Sujet : Passage des tuyaux d'extincteur

Subject: Fire extinguisher pipes

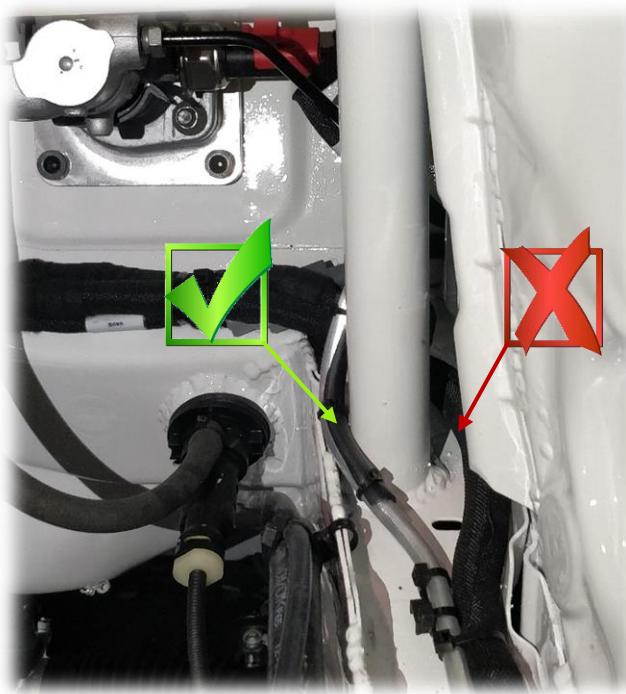
Conformément à l'article 253 de l'annexe J, nous vous rappelons qu'il est interdit de faire passer le tuyau d'extincteur entre l'armature de sécurité et la coque.

A ce titre, il est interdit de faire passer le tuyau d'extincteur entre le renfort de fixation de berceau avant et le passage de roue de votre 208 R2.

In accordance with section 253 of Appendix J, we remind you that it is not allowed to route the fire extinguisher pipe between the safety cage and the bodyshell.

As such, it is not allowed to route the fire extinguisher pipe between the front subframe mounting reinforcement and the wheel arch of your 208 R2.
